# Access Compliance Report

## Public Rights-of-Way

Intersection ID: 31202	Main Street: OAKTON_HUNT_DR	Cross Street: WRAYHILL_DR	Location: S
ADA ID: 6600C579B33C	Ramp Type: Perpendicular Diagonal	Initial Pass/Fail: Fail	Overall Compliance: No
		Severity Score: 10

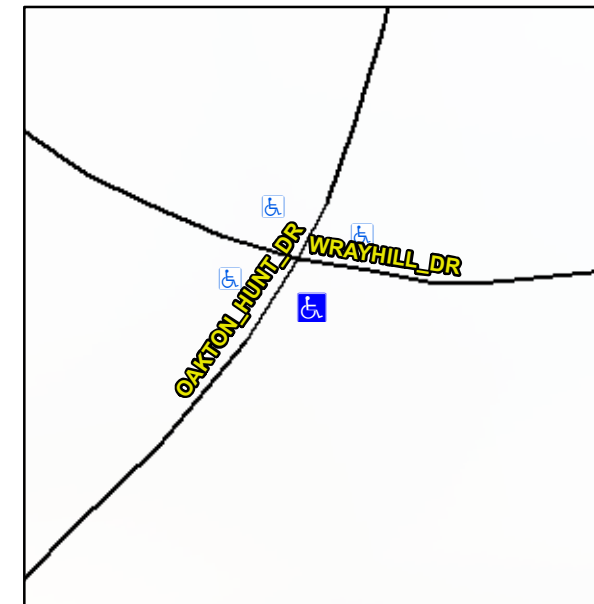
**Not Found, R304.5.1, R304.5.3**

Compliance	Description	Data	Compliance	Description	Data
N/A	Ramp Length (in)	48.0	Yes	Ramp Slope (%)	5.2
No	Ramp Width (in)	41.0	No	Ramp XSlope (%)	4.9
N/A	Flare Type LT	N/A	N/A	Flare Type RT	N/A
N/A	Flare Slope LT (%)	N/A	N/A	Flare Slope RT (%)	N/A
N/A	Flare Traversable LT?	N/A	N/A	Flare Traversable RT?	N/A
N/A	Landing Length (in)	N/A	N/A	DWS Provided?	N/A
N/A	Landing Width (in)	N/A	N/A	DWS Contrast?	N/A
N/A	Landing Slope (%)	N/A	N/A	DWS Length (in)	N/A
N/A	Landing X Slope (%)	N/A	N/A	DWS Full Width?	N/A
N/A	Landing Curb? (Y/N)	N/A	N/A	DWS Offset (in)	N/A
N/A	Shared Landing?	N/A			
N/A	Gutter Ponding?	N/A	N/A	Gutter Slope (%)	N/A
N/A	Gutter Lip Ht (in)	N/A	N/A	Gutter X Slope (%)	N/A
N/A	Painted X Walk1?	No	N/A	Painted X Walk2?	No
	X Walk 1 Direction	To NE		X Walk 2 Direction	To NW
N/A	X Walk 1 Width (in)	N/A	N/A	X Walk 2 Width (in)	N/A
	X Walk 1 Slope (%)	6.0		X Walk 2 Slope (%)	5.6
	X Walk 1 X Slope (%)	4.2		X Walk 2 X Slope (%)	3.7

**Remove & Replace Curb Ramp With Two New Directional Ramps or Equivalent.**
